ANN ARBOR HISTORIC DISTRICT COMMISSION

Staff Report

ADDRESS: 1113 W Liberty Street, Application Number HDC14-174

APPLICATION: The applicant seeks HDC approval to remove a rear partially-enclosed porch and replace it with a one-story rear addition that contains access to the basement stairs, a pantry, and half bath.

PROPOSED SITE PLAN

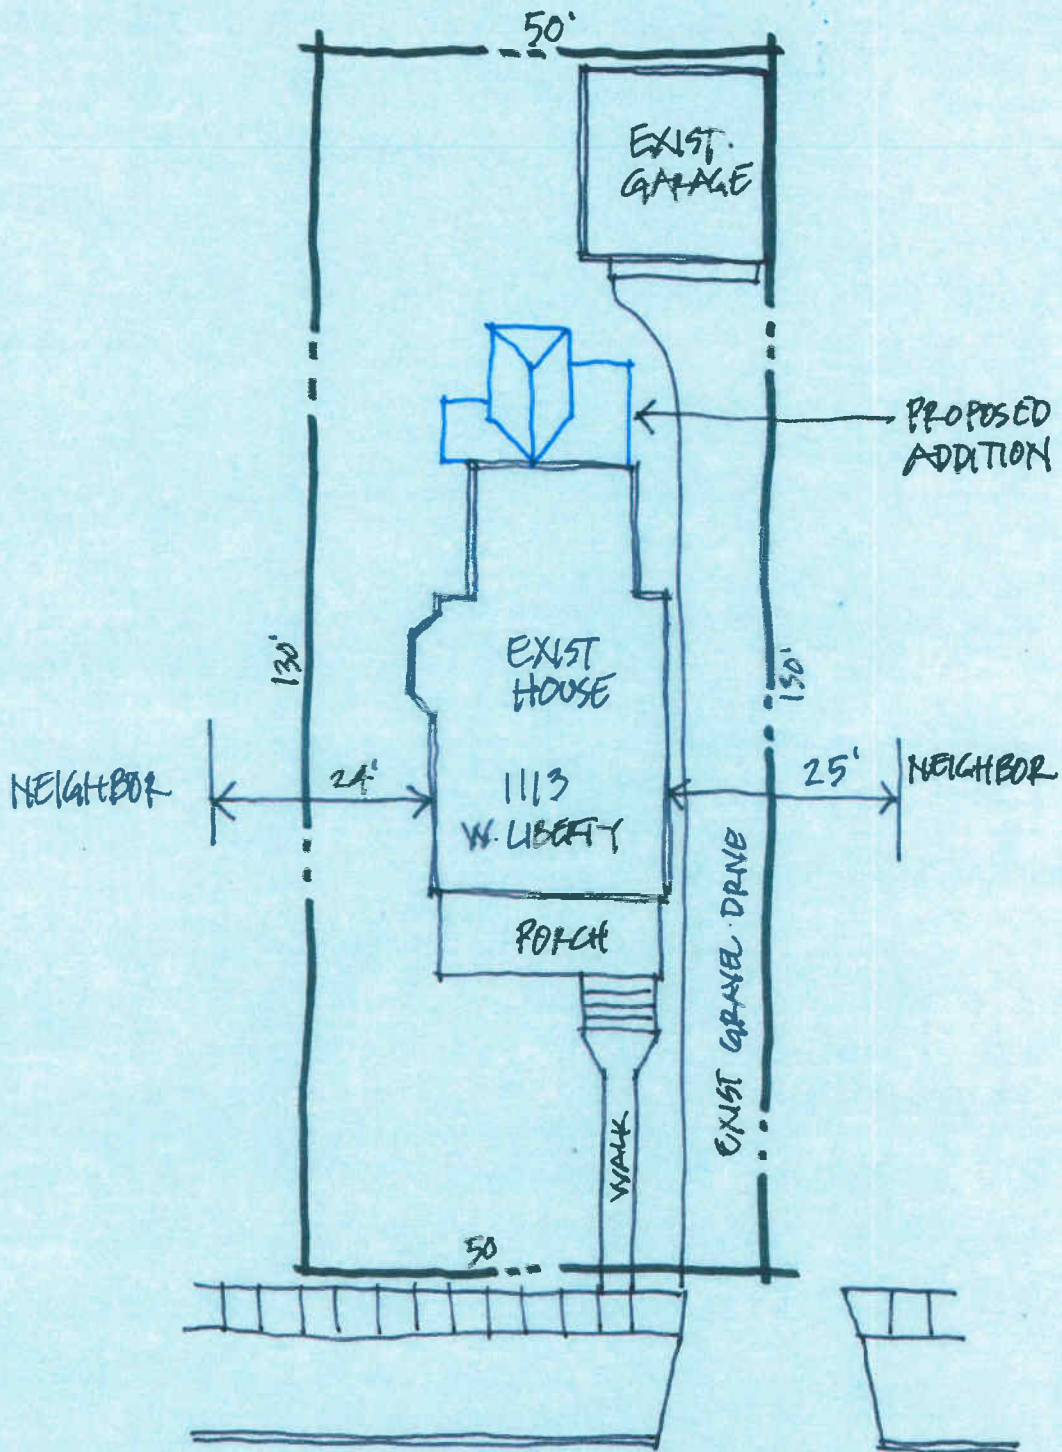
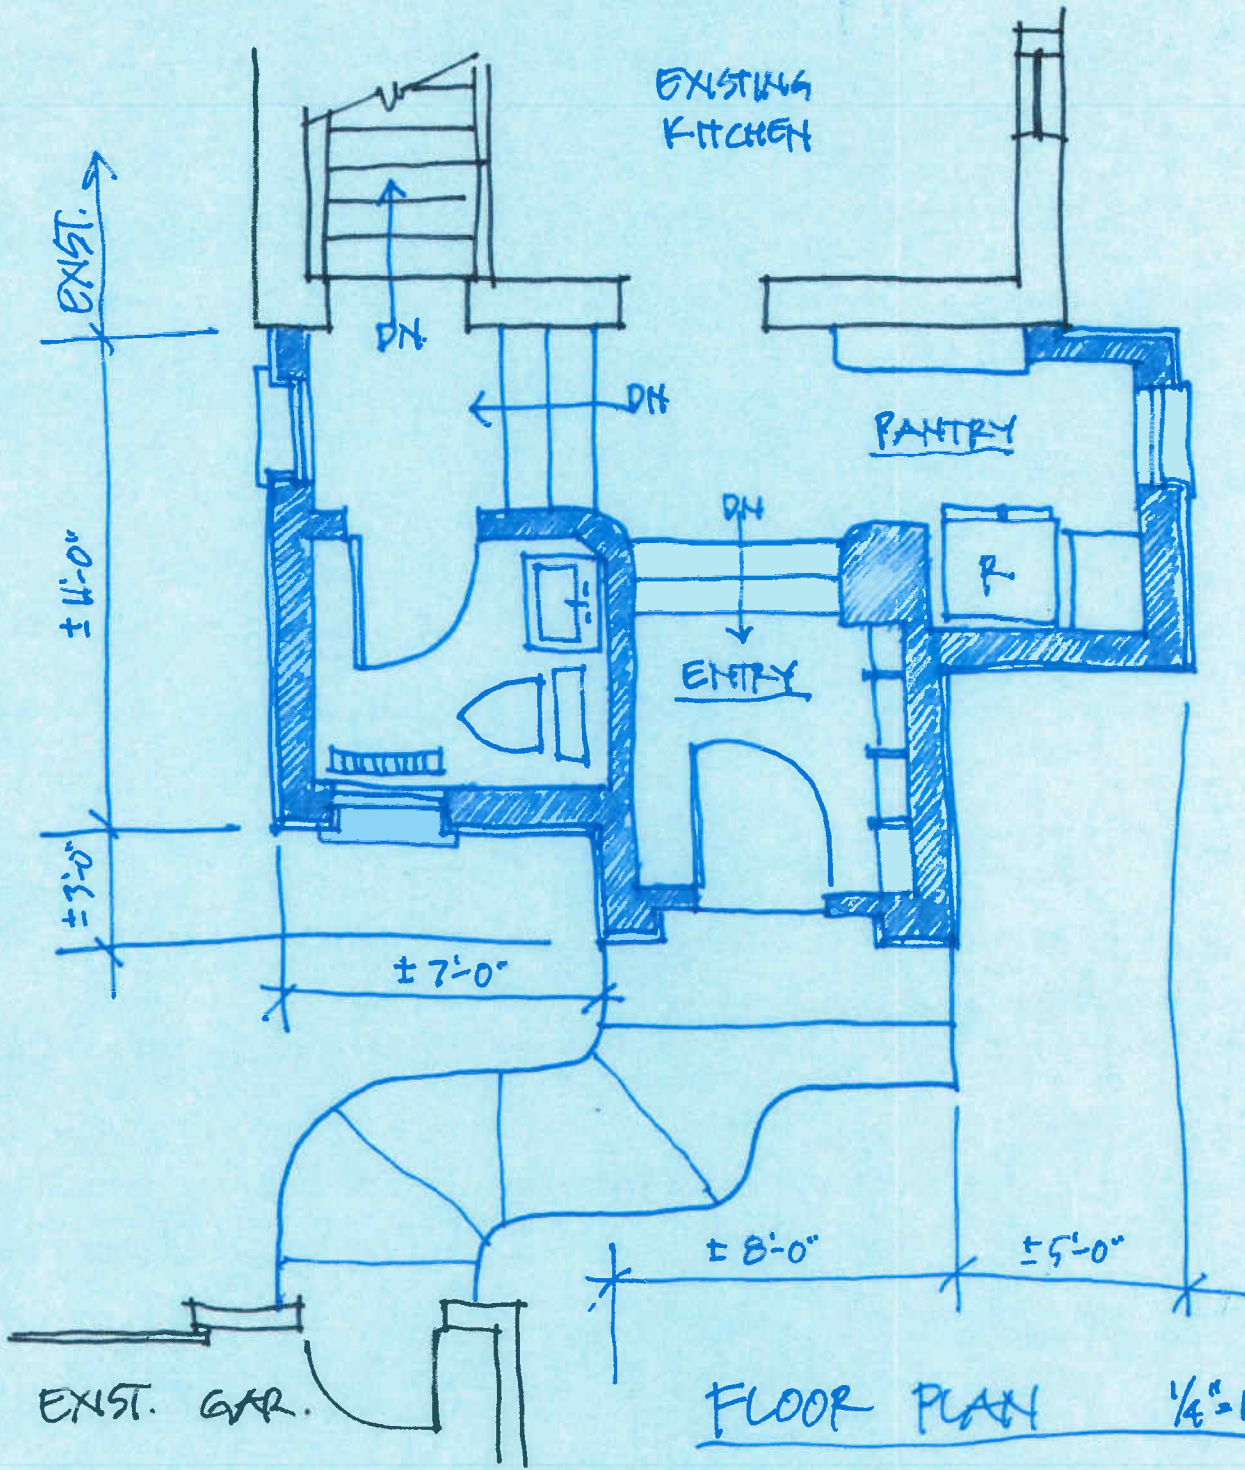
2. The homeowners are requesting to remove this porch and construct a single-story addition across the back of the house. The addition is 20' wide and ranges from 8' to 14' deep. The addition would be slightly inset from the southwest corner of the house, and slightly overshoot the southeast corner. The design of the one-story addition is modern and distinct from the remainder of the house. It would be clad in horizontal wood siding with wood double-hung windows. Some of those windows are six-over-one double hungs, similar in style to the historic windows on the house, but this is not problematic since the addition is clearly modern. Those windows have applied interior and exterior muntins. Two rear door openings would be incorporated into the addition (and obscured by it). The existing rear door would be restored and re-used on the addition, with three fixed clerestory windows above it.

3. The location of the addition is appropriate and subordinate to the existing house. It is on an inconspicuous elevation, and does not negatively impact the relationship between this building, neighboring buildings, and the landscape.
